Corporation of the Town of Erin  
5684 Trafalgar Rd.  
Hillsburgh, ON  
N0B 1Z0

Attn: Ms. Tanjot Bal, Senior Planner

**Re: Response to 2<sup>nd</sup> Submission Comments  
Traffic Impact Study Updated July 28<sup>th</sup>, 2022  
Hillsburgh Heights Inc.  
Proposed Residential Subdivision  
5916 Trafalgar Road North  
Town of Erin  
Town File No. 23T-21002, OP21-01 & Z21-09  
Our File No. W21081**

Figure No: 6  
Date: January 13 2023  
Prepared by: B.W.

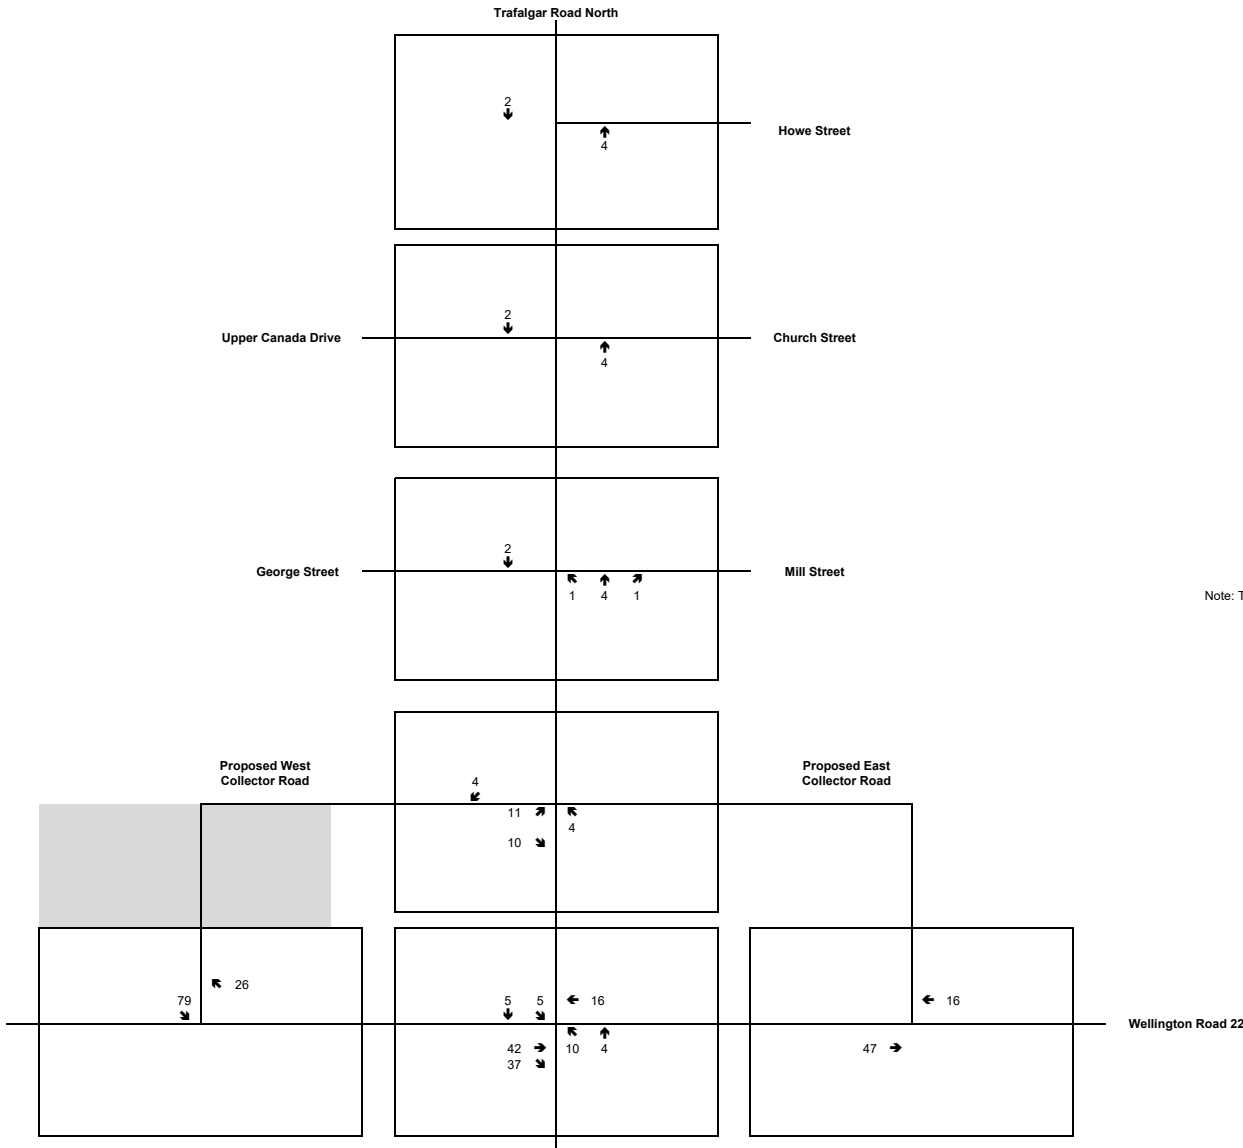
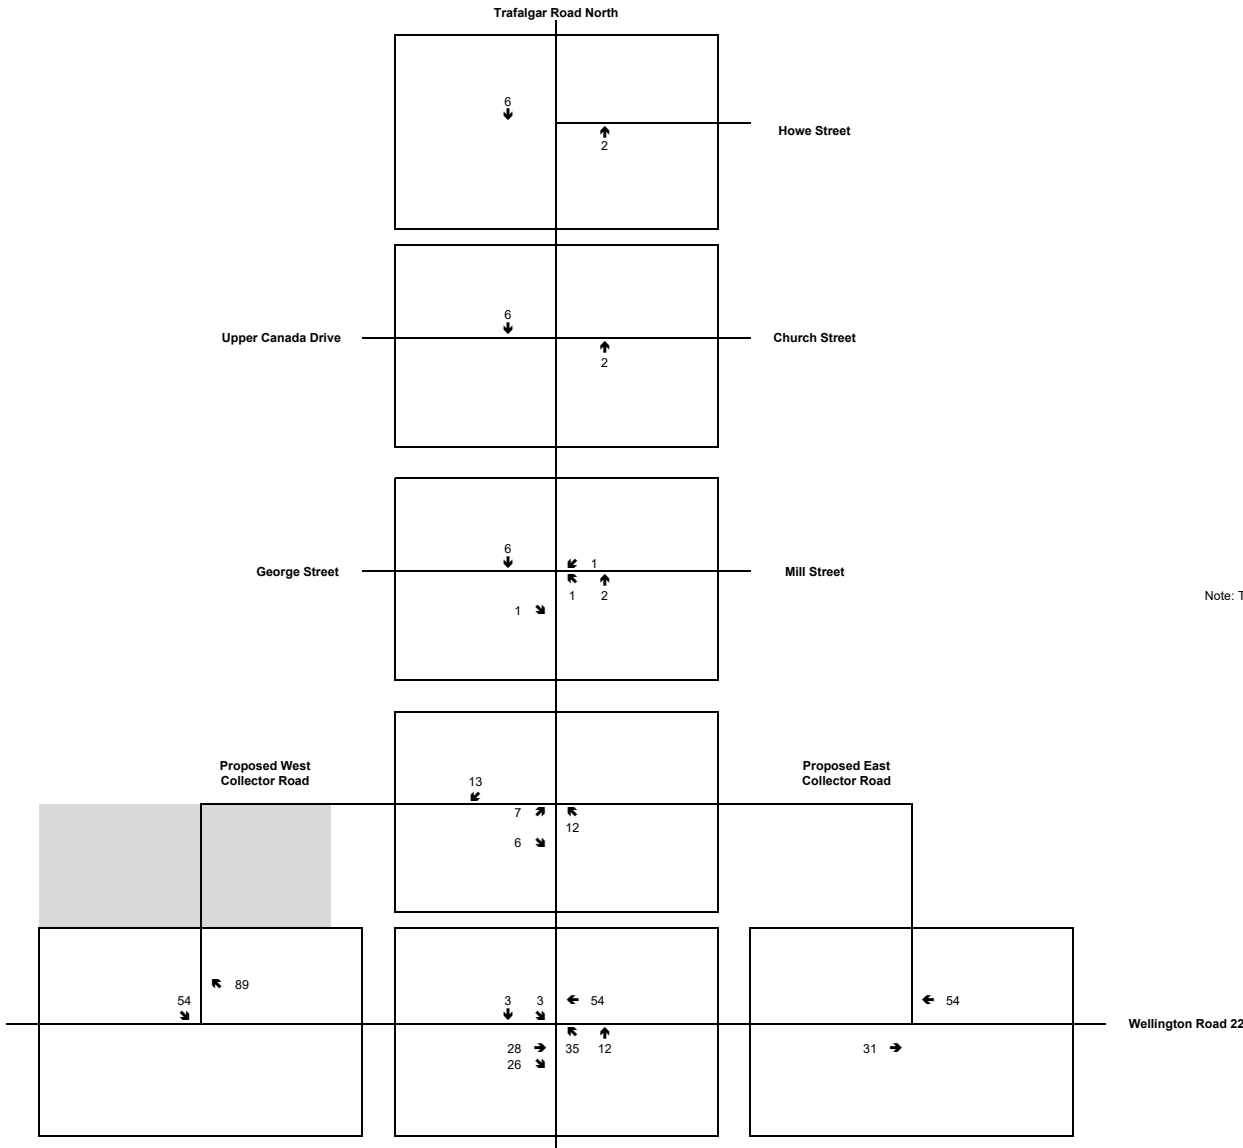
The trip assignment for the anticipated background developments owned by Carson Reid Homes Ltd (**Figures 6 and 7**), Thomasfield Homes Ltd (**Figures 8 and 9**), Tavares (**Figures 10 and 11**), and Chantler (**Figures 12 and 13**) were revised accordingly and are attached.

Figure No: 24  
 Date: January 13 2022  
 Prepared by: B.W.

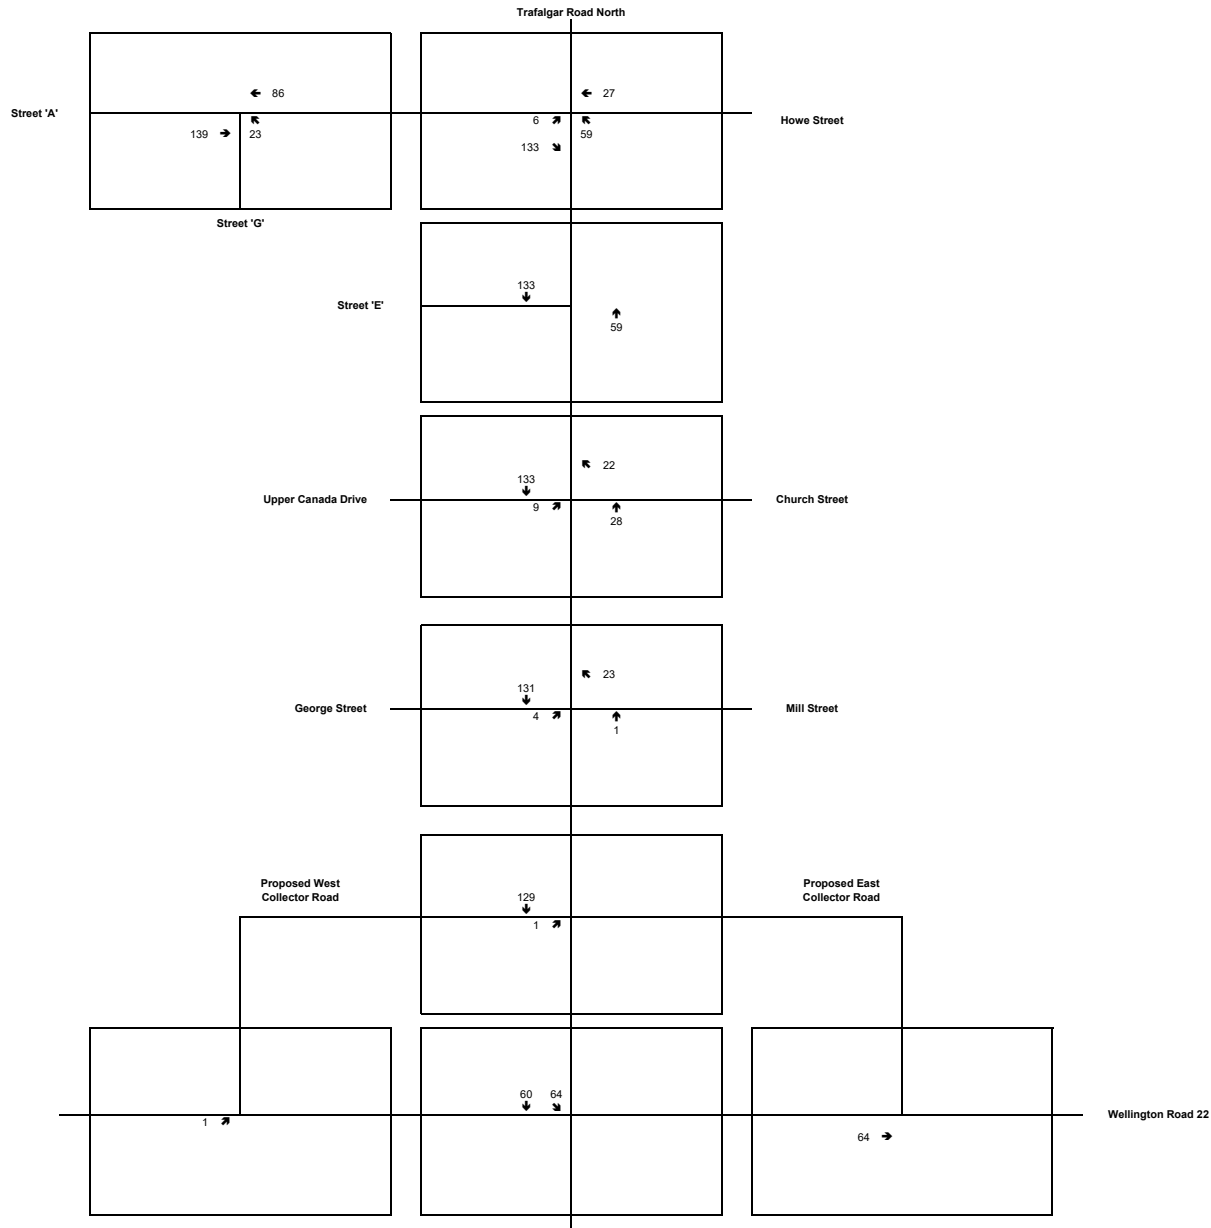
The Future (2026 & 2031) Total Traffic Volumes (**Figures 32, 33, 36 and 37**) were updated to account for the revised trip assignment for the anticipated background developments (**Figures 6 and 13**), the removal of the anticipated background development that was immediately north of the Subject Subdivision and the reassignment of the trips generated by the elementary school within the Subject Subdivision for the 2031 horizon year (**Figures 24 and 25**).

LEFT-TURN LANE WARRANT ANALYSIS  
FUTURE (2026) TOTAL TRAFFIC  
TRAFALGAR ROAD NORTH AT HOWE STREET/STREET 'A' - NB APPROACH

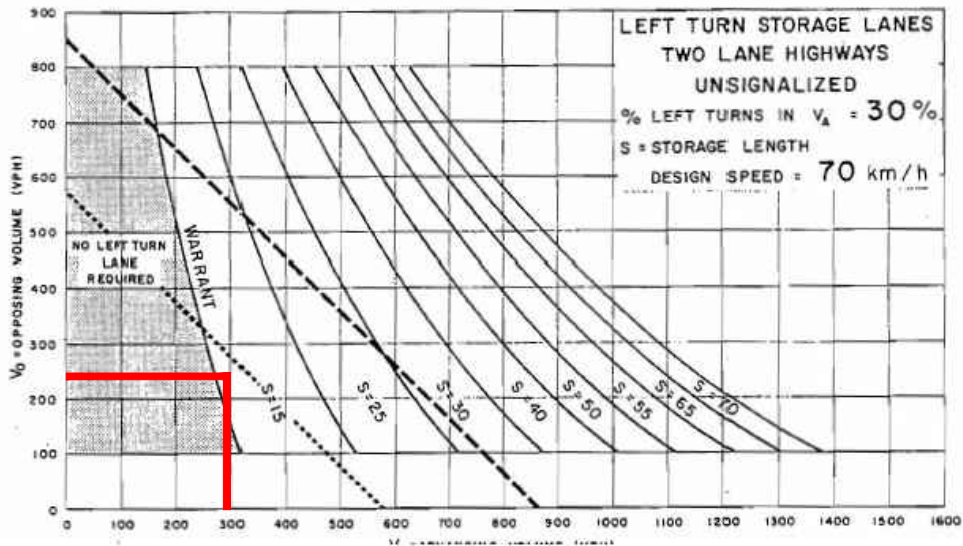
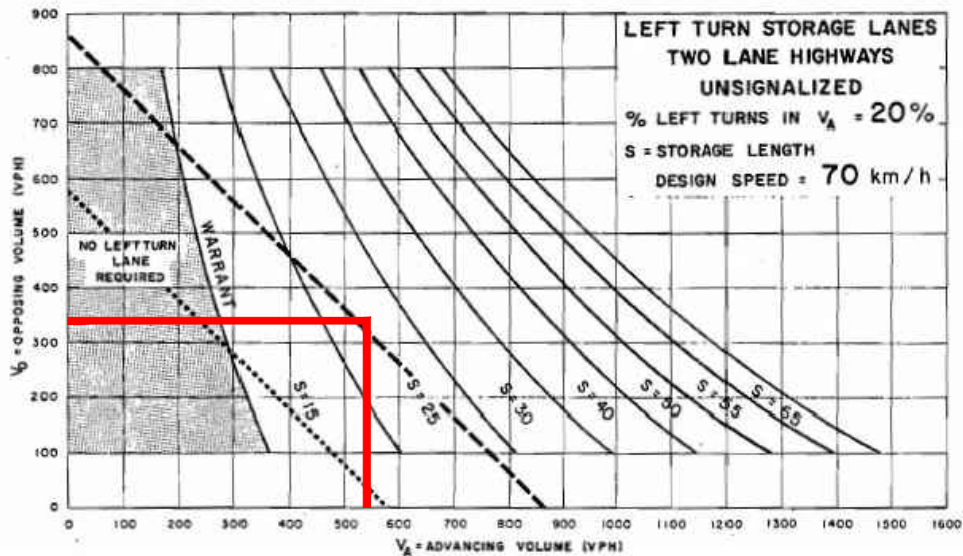
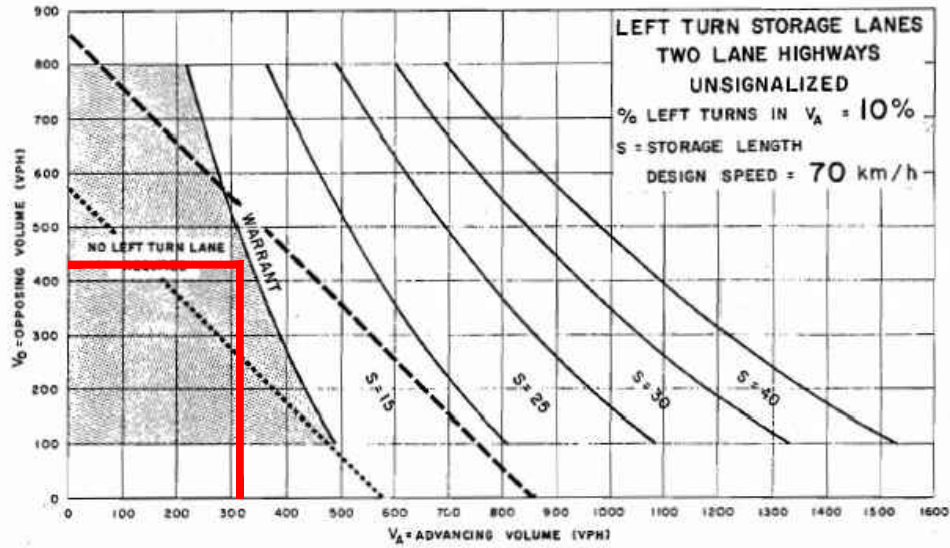
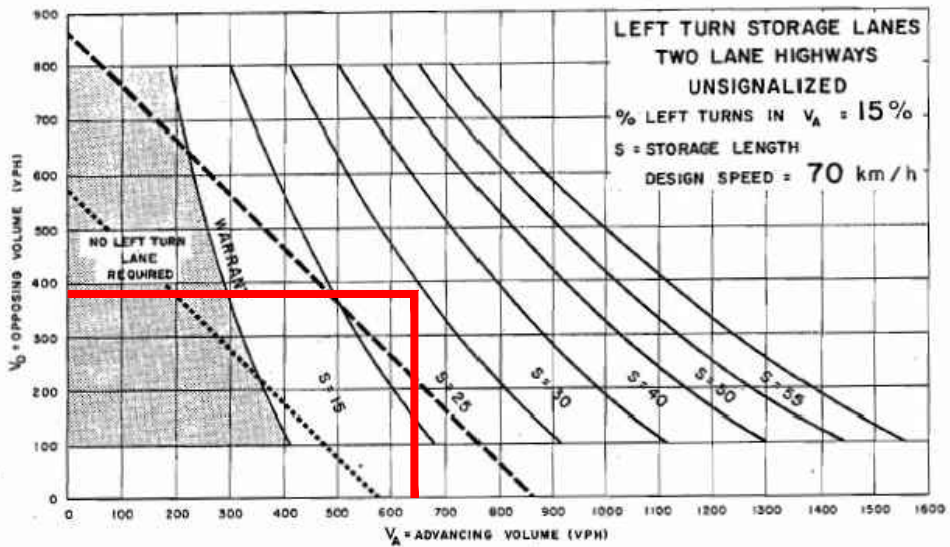
*Partially done, the LT turn warrant shows a 25m length requirement, but only provides 15m.*

For the northbound left turning movement at the Trafalgar Road North at Howe Street/proposed Street 'A' and Trafalgar Road North at proposed Street 'E' intersections, the left-turn lane warrant analysis that is illustrated in **Figures 34 and 35** was updated to reflect the revised volumes for the Future (2026) Total Traffic Scenario. The analysis followed the procedure specified in the Ministry of Transportation Ontario's Geometric Design Standards for Ontario Highways.

DRAWN BY: B.W.	PROJECT No. W21081
CHECKED BY: D.L.	FIGURE
SCALE: N.T.S.	<b>A</b>
DATE: FEB. 16th, 2023

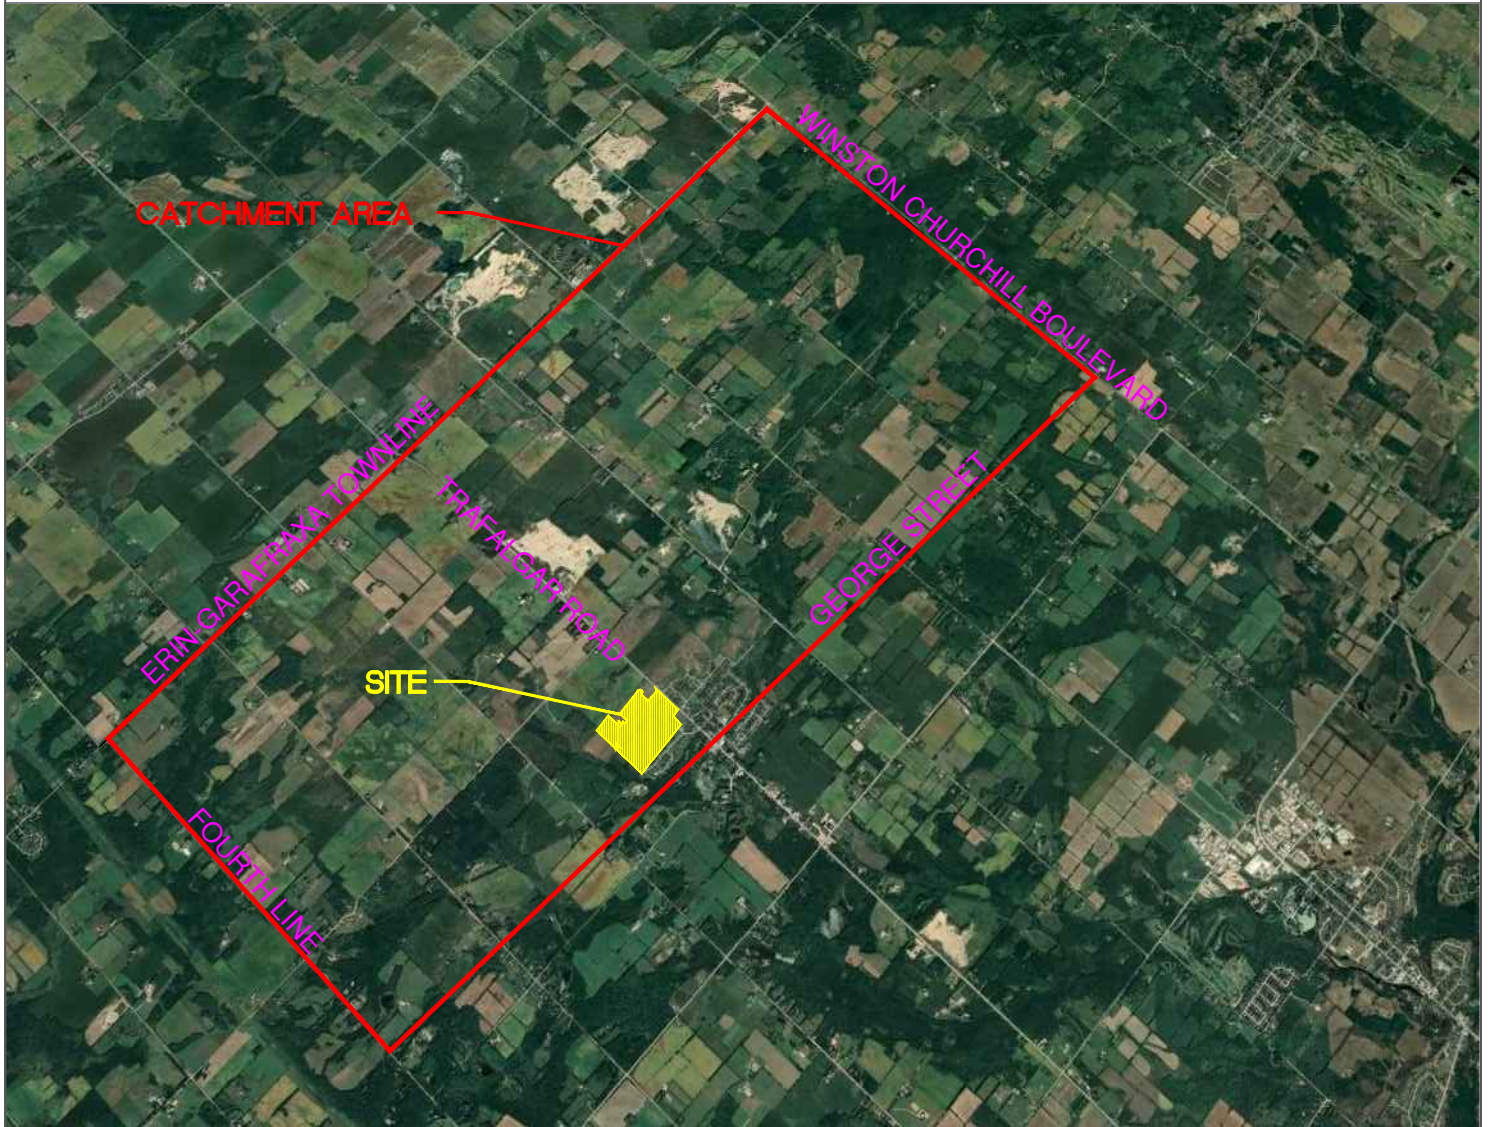
In the Traffic Impact Study Update, the catchment area for the proposed Elementary School was assumed to be bounded by Erin-Garafraxa Townline to the north, Winston Churchill Boulevard to the east, George Street to the south and Fourth Line to the west. After reviewing the residential land use within the attendance area, we find that the capture rate of 47% that was assumed is appropriate. The boundaries of the attendance area and the residential land uses within the attendance area are illustrated in **Figure A**.
